Subject 353 KEB.

**MUNICIPAL CORPORATION,
KARACHI.**

Reference No. B. S. P. 53/41

PLAN FOR PROPOSED BUILDING ON PLOT No 353 K.E.B.

R.C.C. PLAN OF LOT N^o 353 K.E.B.

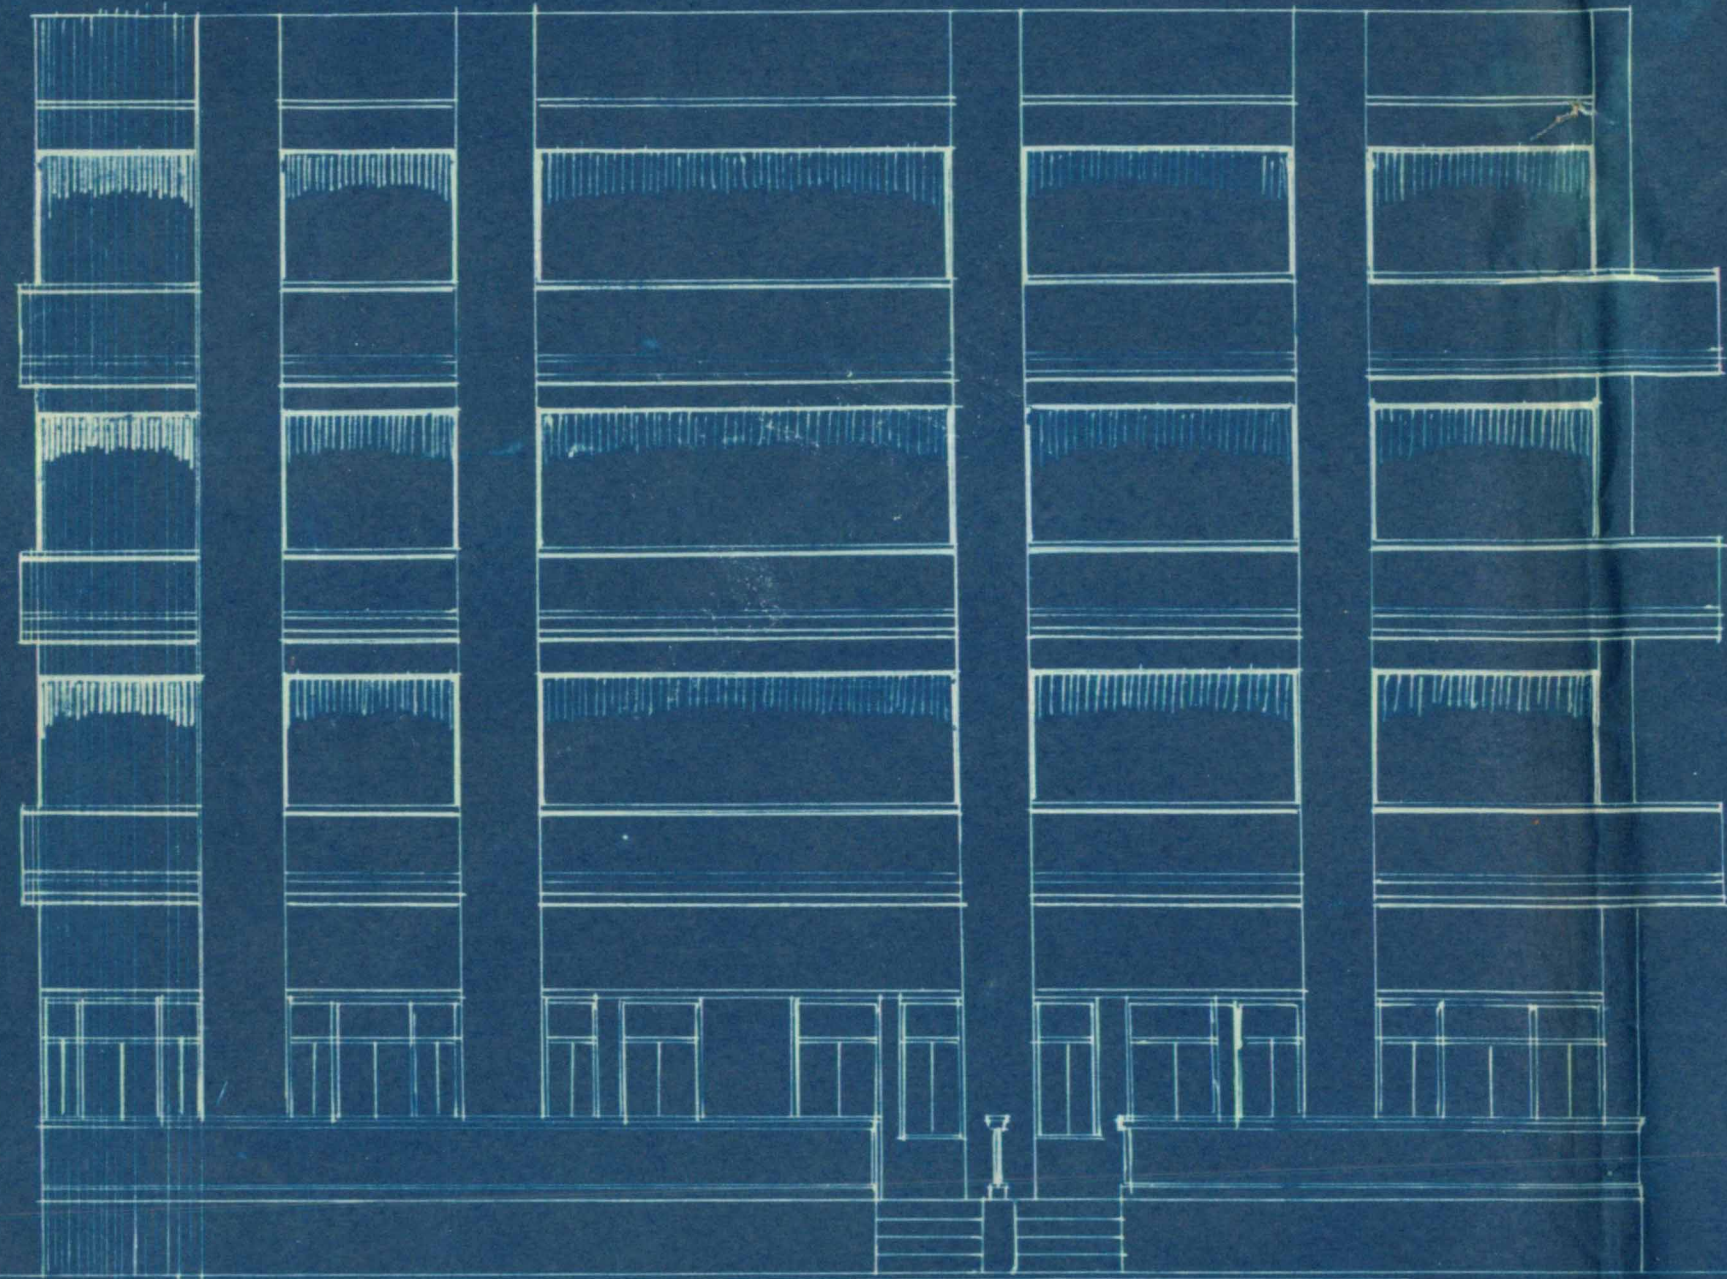
- (2) Shops cannot be allowed without K.E.B's sanction.
(3) Objections 6 & 10 dated 10th March 1941 stand.
(4) Size of the rectangular R.C.C. pillars be given.
(5) Size of all the R.C.C. beams be specified.
(6) Balconies overhanging the Ramchandra Temple Rd.
join two rooms and cannot be allowed.
(7) Sketch showing the special conditions of grant,
compulsory open space etc. must be produced
from the Karachi Estate Board.

- (4) Title deed be produced.
- (5) One room tenements cannot be allowed.
- (6) Height of partitions between the rooms on ground floor be shown.
- (7) Separate R.C.C. plan is required.
- (8) Balconies joining two rooms cannot be allowed to overhang the compulsory open space.
- (9) K.E.B.'s sketch re. compulsory open space and conditions, if any, must be submitted.
- (10) Calculations of built up area must be got checked.
- (11) Distance of the staircase pillars from the boundary be given.
- (12) It must be stated if the southern staircase is open to sky.

R.C.C. Pillars.

GROUND FLOOR. 18x18. 4 RODS 3/4 -

1st Floor. $16\frac{1}{2}'' \times 16\frac{1}{2}''$ 4 Rods $\frac{5}{8}''$

2 ND FLOOR. 15" x 15" 4 RODS 5/8"

3 RD FLOOR. 14' x 14', 4 ROOS 5/8'

5. There are no one room tenements now. Shops are shown on the ground floor.
6. Height of partitions between rooms is 7' 6" high.
7. Separate R.C.C. Plan is attached herewith.

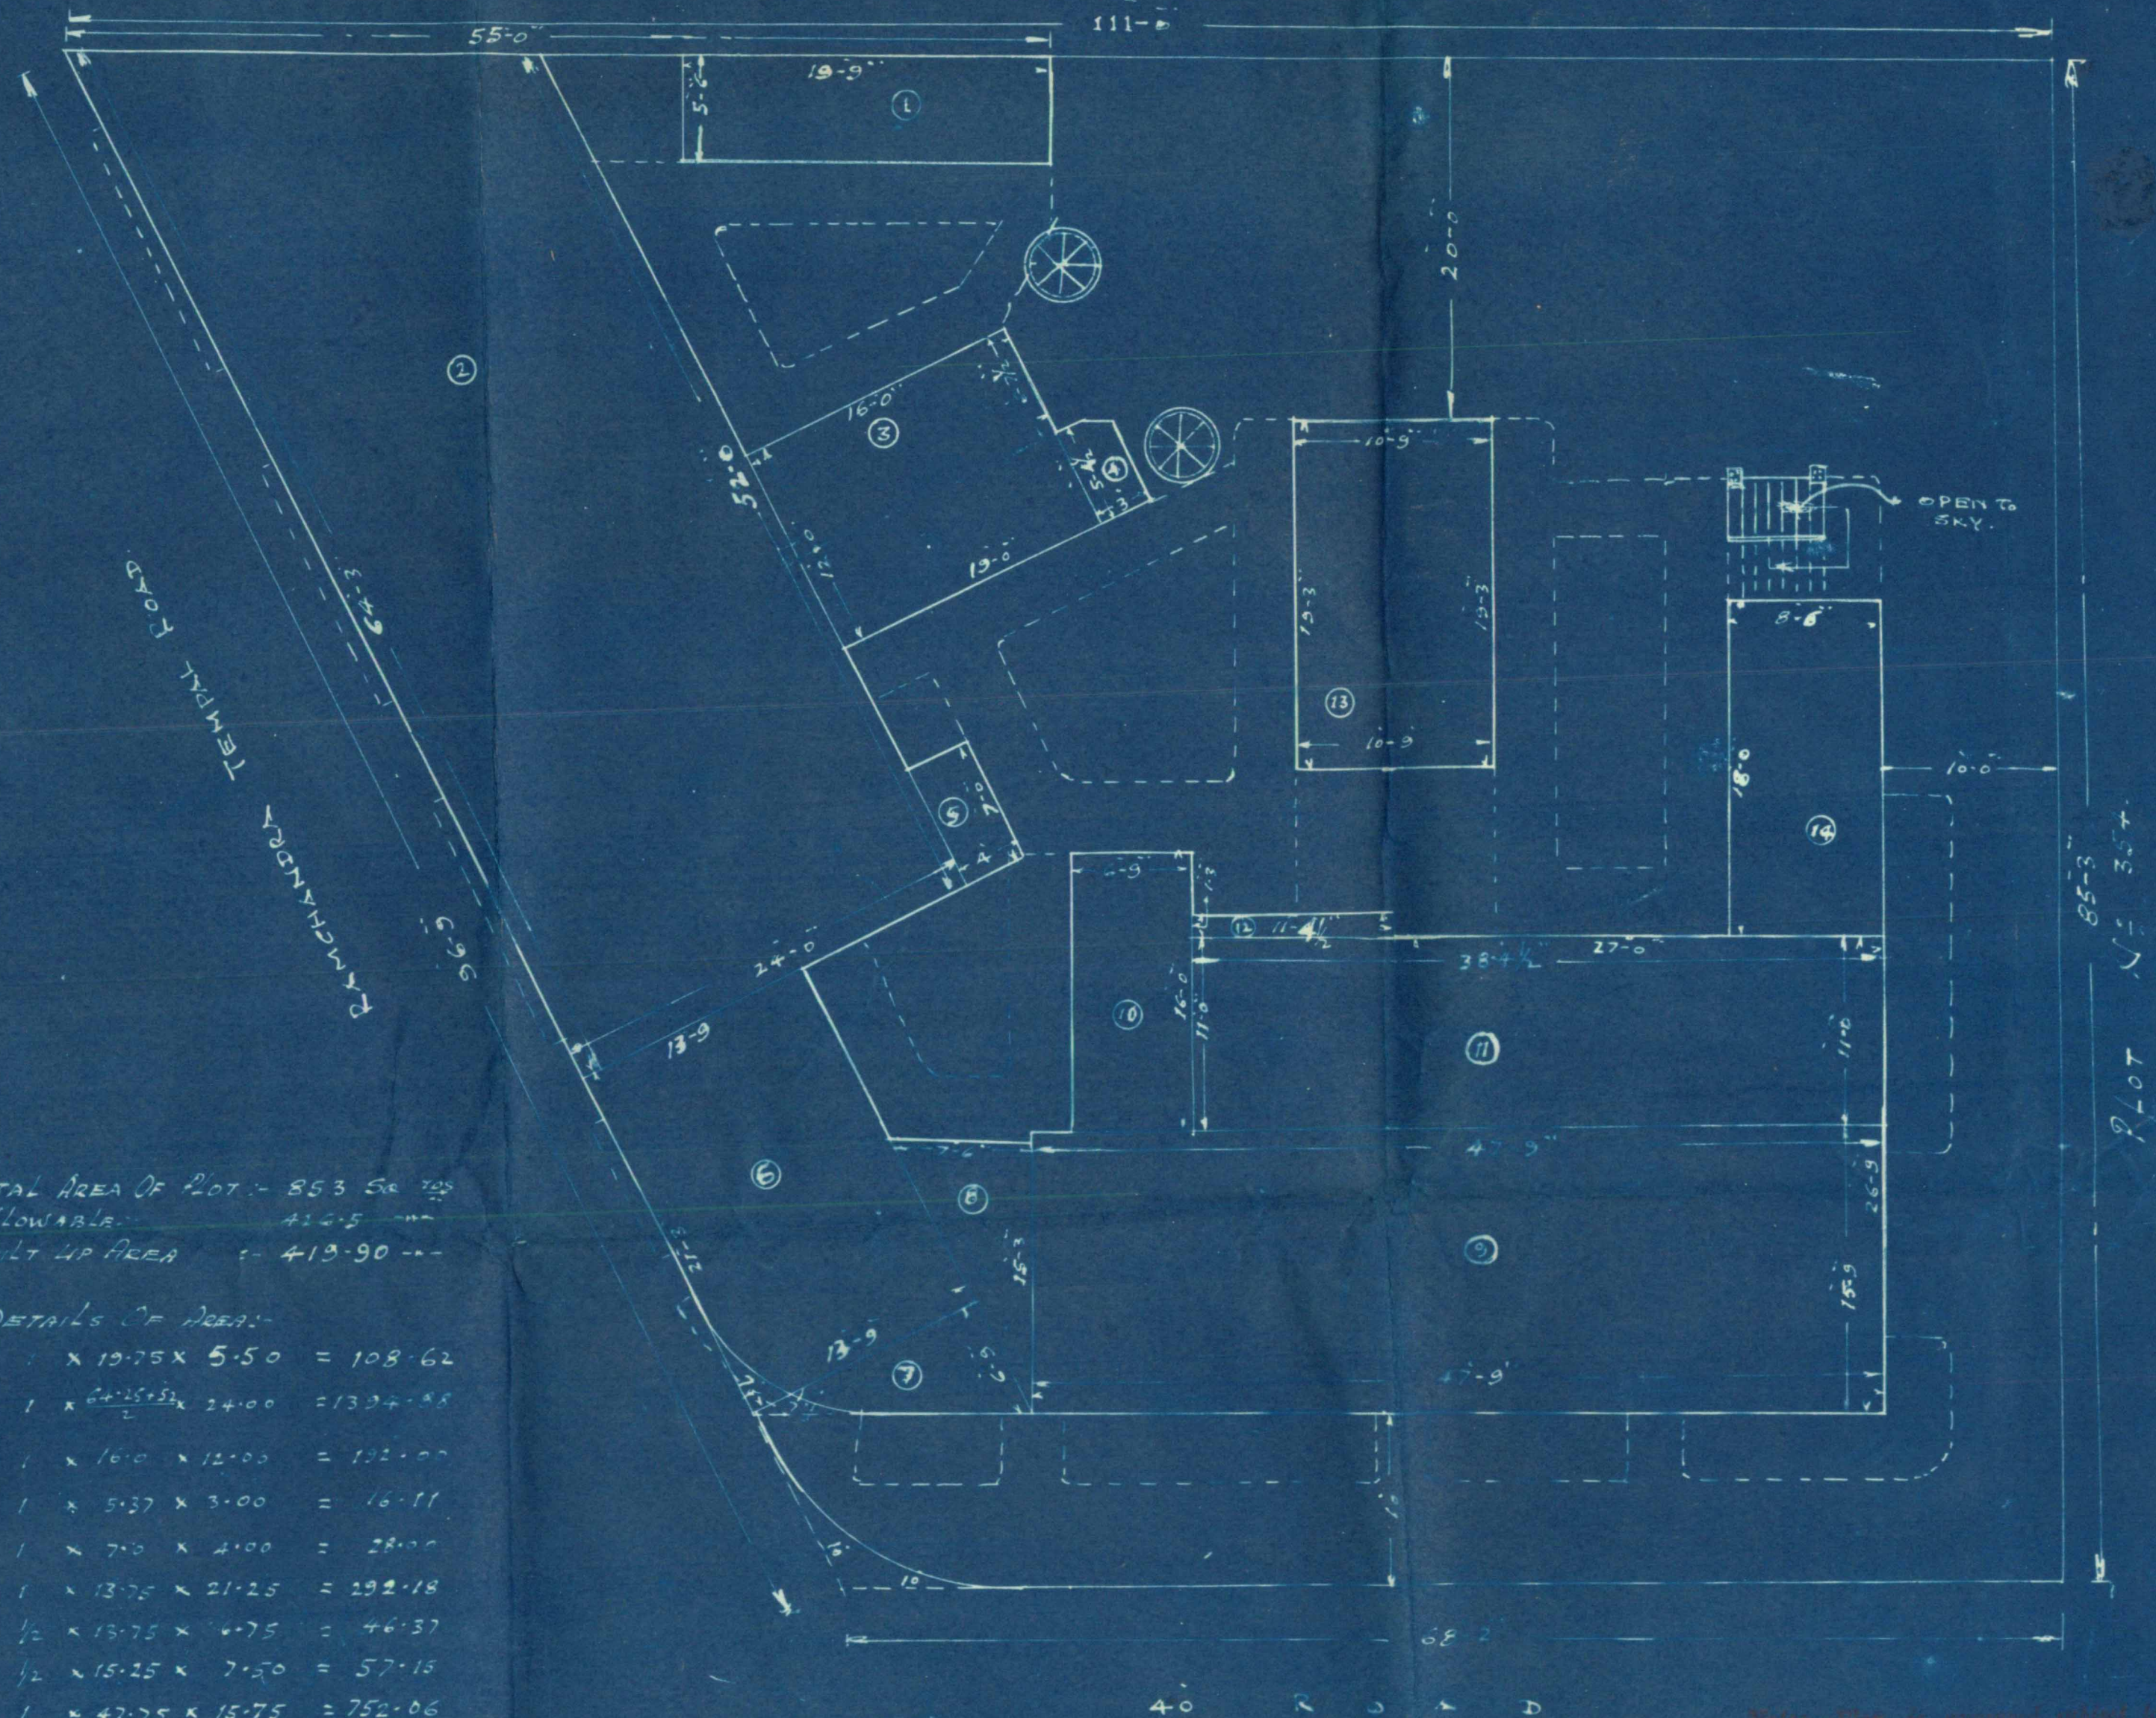
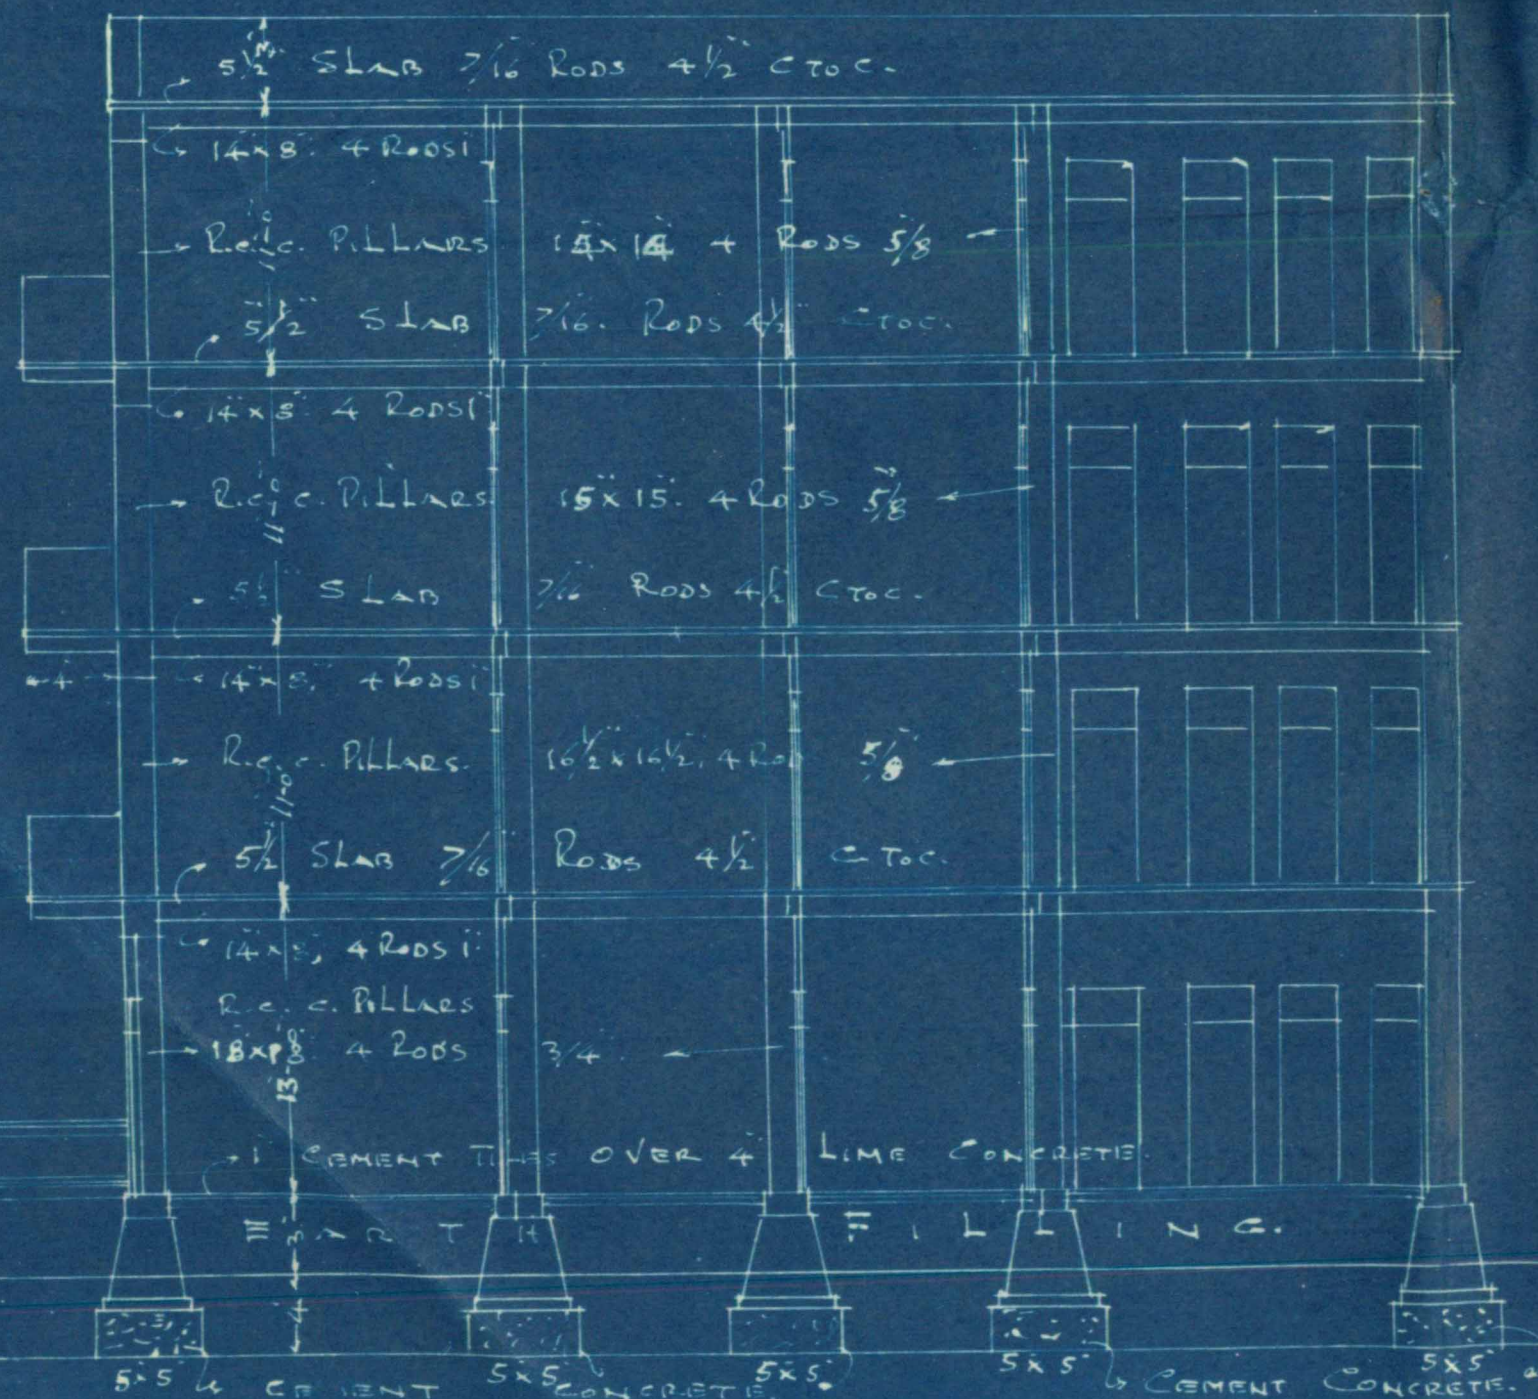
- (1) Drainage lines should not pass below staircase.

- (1) Only one drainage connection can be granted.
- (2) There is no sewer on Ramchandra Temple road where a connection is proposed.
- (3) O.H. tank should be at least 2' away from adjoining plot.

1. Drainage line can pass under the Passage near the Main road. The staircase in the ground floor is in three flights. ~~This cannot be objected to~~
2. For objection No 2 and 7, Karachi S.C. Board may be referred to.
3. For the height of rooms in the ground floor, it is not necessary to keep them 7'6" high as on 1st floor. Because the two rooms are enclosed with one shop and then there are two rooms, the back room has enough air hole. P.W. 10, Calculation are enclosed.
4. Size of Rectangular pillars is given as 12" x 24".
5. Size of all the Rec beams are specified.
6. There are no balconies to two rooms, but they are Verandahs of 2'6" and with galleries, they will be 6'6" the rooms also as a Verandah. Such cases have been allowed before for instance plot No 25 KEB and 47 SR13, 46 SR13 and 54 KEB.

1. Only one drainage connection is shown.
2. Connection on Ramchandra Temphe Road is deleted.
3. O.H. Tank will be 2' ft away from the adjoining plot and note is writtern on the plan already.

4. There is no title deed. It is directly purchased from Karachi Estate Board. The fact that the Hon: Secretary has forwarded the plans to you, indicates that the ownership is correctly shown in the plan.

8. There is no balcony joining two rooms. Balcony is proposed to a Varandah only.
9. K.E.B. sketch is not with us. They always send you the copy of it. Or you can refer to them. As a matter of fact, they certify the boundries and compulsory open spaces and the consulting Surveyor certifies and signs the plans before they are sent to you.

10. Calculations of built up area are checked

11. Distance of the stair case from boundary line is given.

12. The southern staircase is open to sky.
